Informal document **GRE-70-41**
(70th GRE, 21-23 October 2013,
agenda item 4(b))

Alternative aiming/leveling

Tomasz Targosinski Ph. D. Eng

70 GRE 22 October 2013

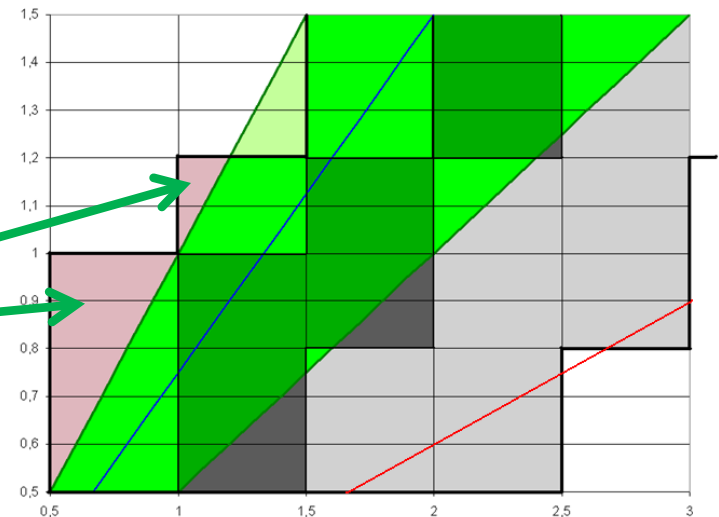
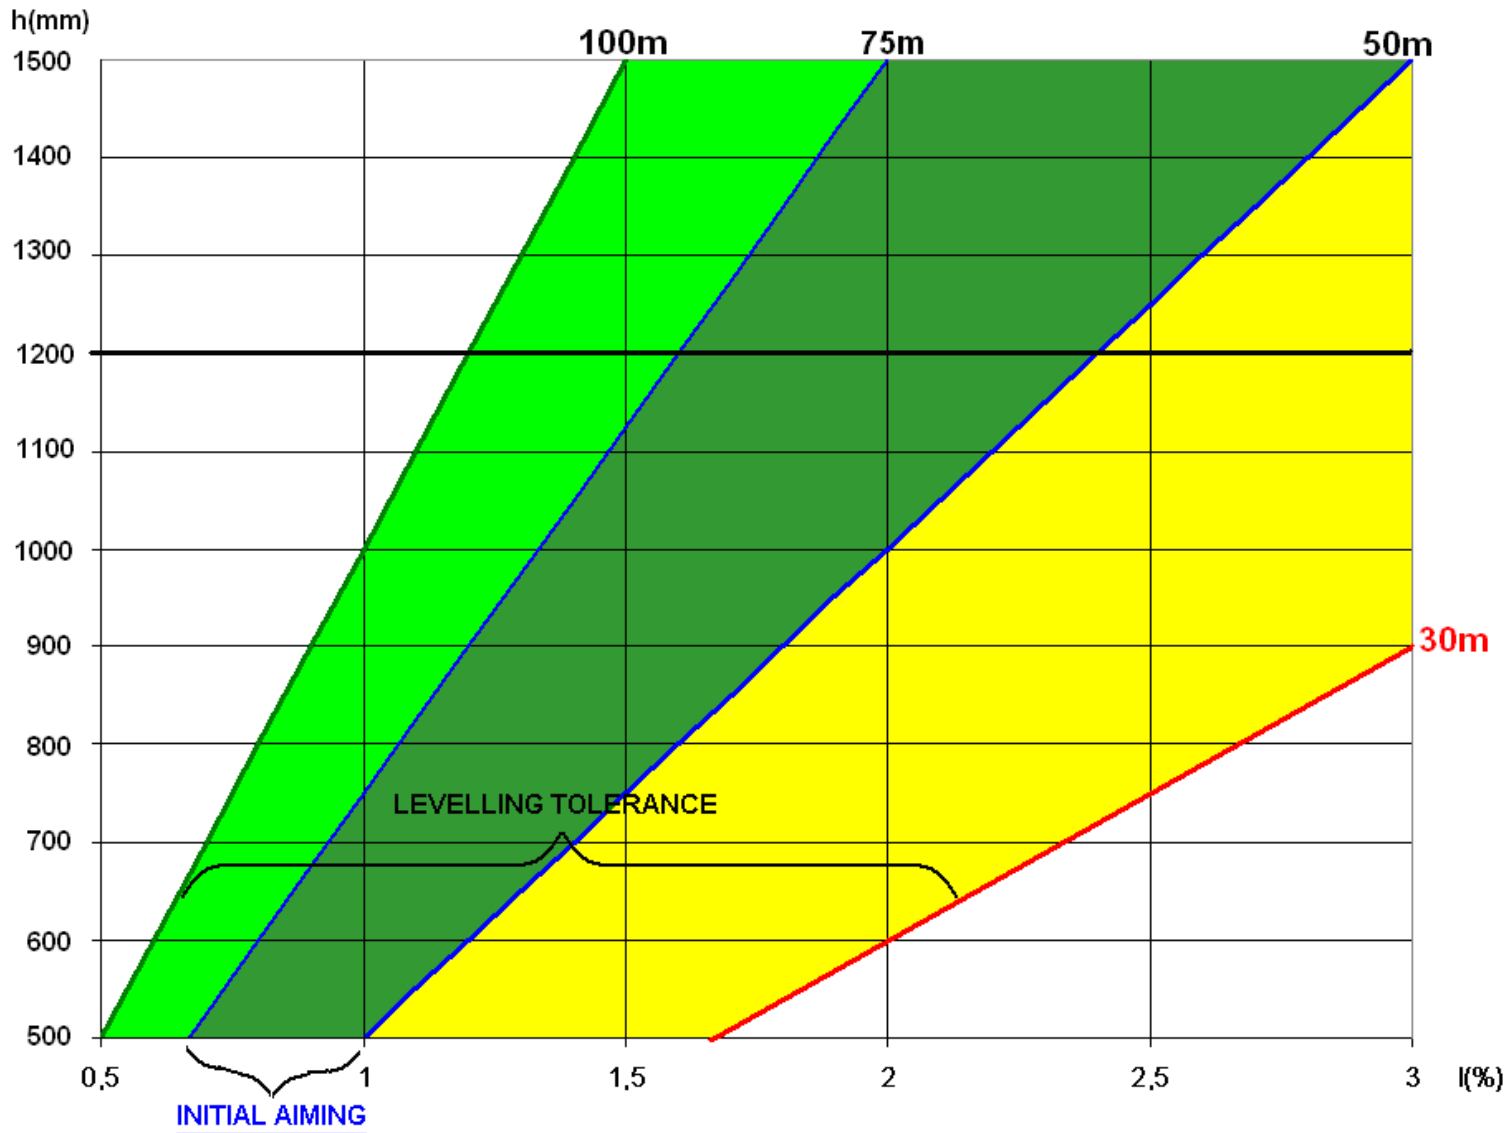
Proposed Initial nominal aim to correspond to 75m theoretical range

- Under proposal,
 - No overlap between height bands
 - Most headlamps would be aimed higher than at present

What for are needed overlaps?

- Risks increased glare.

It will depend on manufacturers decision and choice of range of amended Reg.48 (30 to 100m or 50 to 100m)

It will be safety oriented advantage and goal of amendment because of longer average road illumination distance.

Not true. Decreased glare comparing present state.
